# Flow Meter

## contribution to IEC/IEEE 60802

Günter Steindl  
Siemens AG

May, 2022

**Figure 8-13—Per-stream filtering and policing**

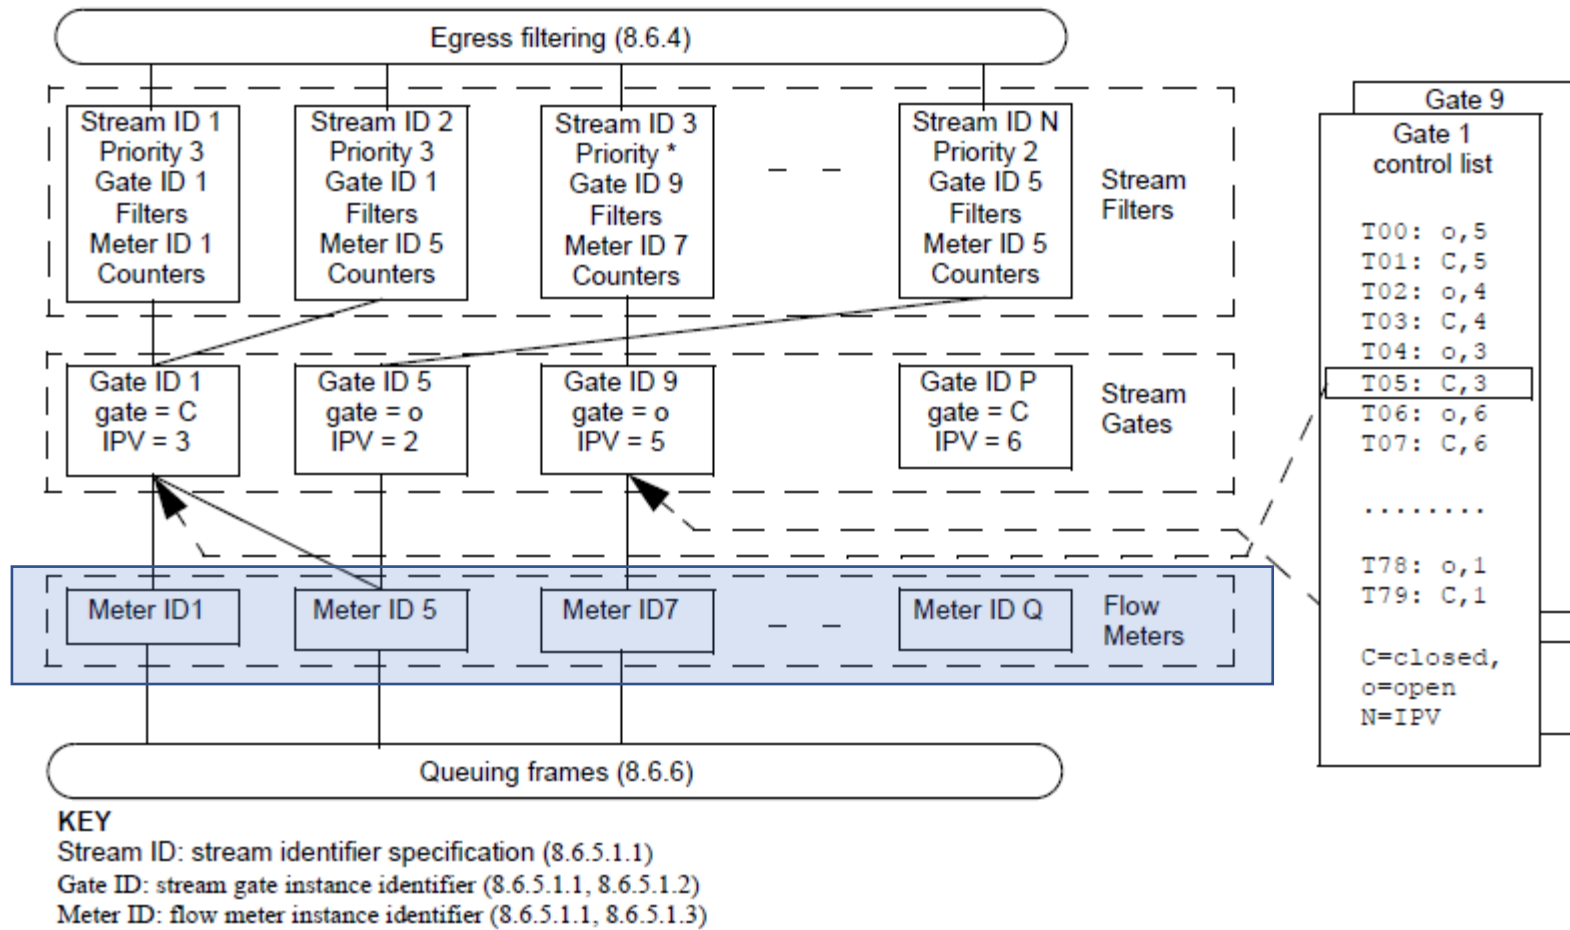
**RED text: Mandatory**  
**BLACK text: Optional**

**Meter ID: flow meter instance identifier (8.6.5.1.1, 8.6.5.1.3)**
